CPC TRANSMITTAL & SUMMARY SHEET
CITY OF RIVERSIDE PLANNING DEPARTMENT

Project Description: PLANNING CASE P04-0486: Proposed plot plan review by PBS&J on behalf of Peninsula Retail Development for a new commercial and retail development on approximately 6.1 vacant acres, situated at the southwest corner of Bountiful Street and Trautwein Rd, in the C-2-SP – Restricted Commercial and Specific Plan (Orangethills) Combining Zones.

ORANGECREST COMMUNITY CENTER PHASE II Plot Plan / Conceptual Grading Plan

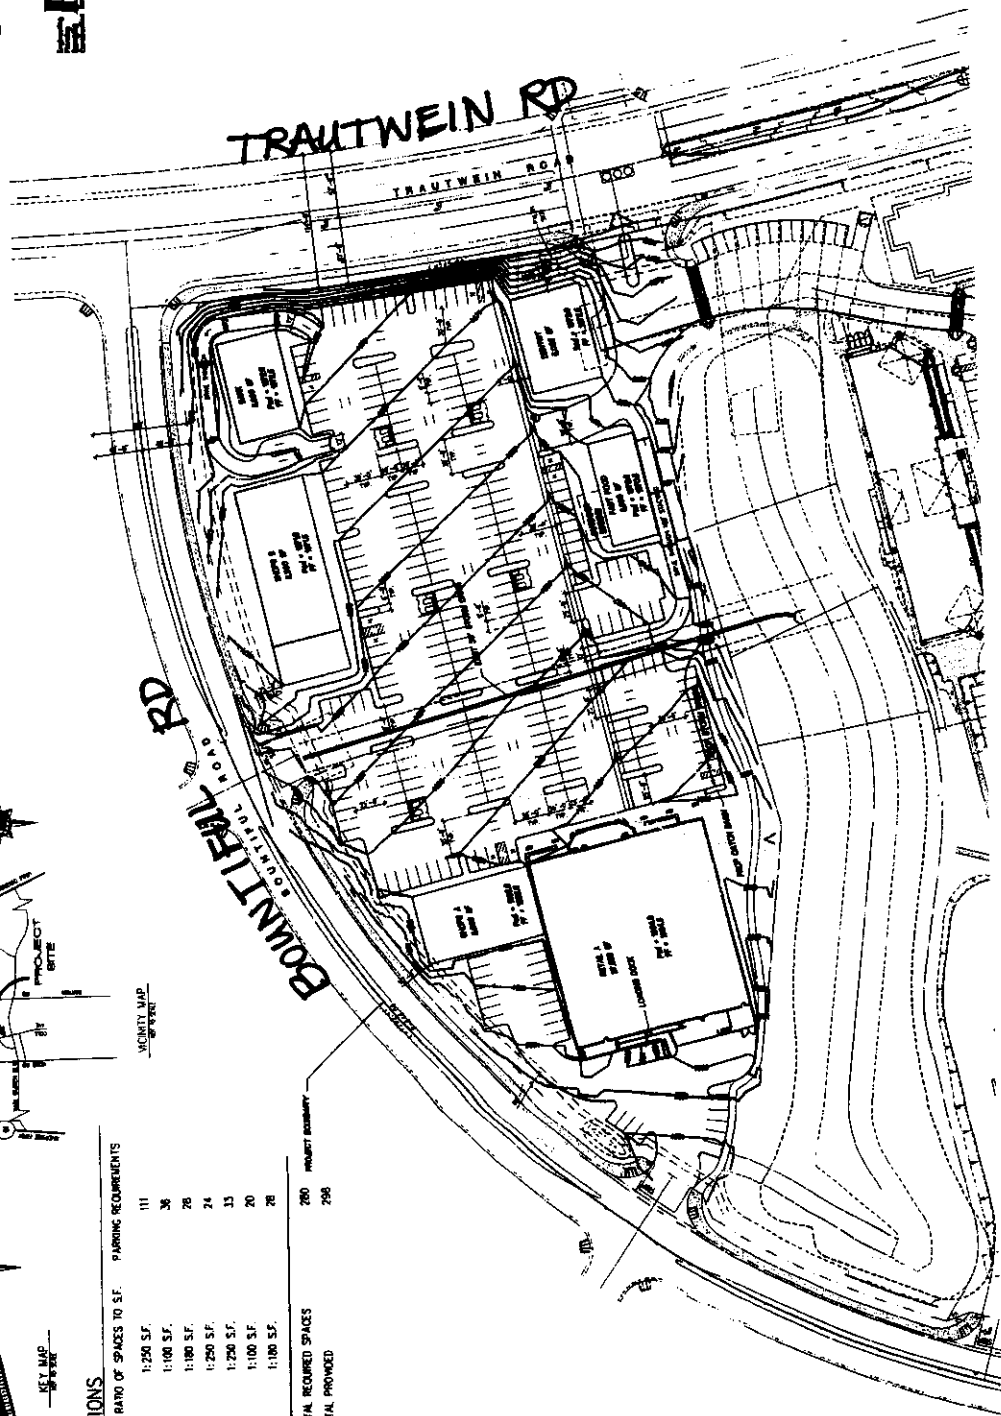
11. The plot plan shall be revised to show a pedestrian walkway connecting the northerly buildings to the southerly portion of the project. The connections should include decorative hardscape and landscaping.
12. Provide a bermed landscape planter along Trautwein Rd and Bountiful Street in order to better screen the drive-thru lane.

Commissioner Leonard asked if there was a plan to screen the trash enclosures.

Commissioner Brown stated he was not signaling out this project, just stating his opinion. He said it would be nice to have a fountain at the center of the parking lot instead of a trash enclosure. The Commission should start doing something other than rubber stamping every new shopping center and add some class. He addressed staff and stated that he would prefer to see the trash enclosures removed and perhaps a fountain that would draw people to it instead of the usual rubber stamp approach to shopping centers.

Commissioner Comer added an advisory condition on the plot plan, that staff work with the applicant to see if he can somehow develop some water treatments at the location to somehow dress up the interior. He said it was not an absolute condition but if the applicant could somehow fit it in. The Commission will start pushing on those kind of things a little bit more.

Mr. Ewing stated that the enclosures were located to provide a central location for the tenants. The objective was to minimize the number of overall trash enclosure. They do have some flexibility in where they are located and would be willing to work with staff on the location. Again, with the screening, he thought the aesthetic impact would be significantly mitigated.
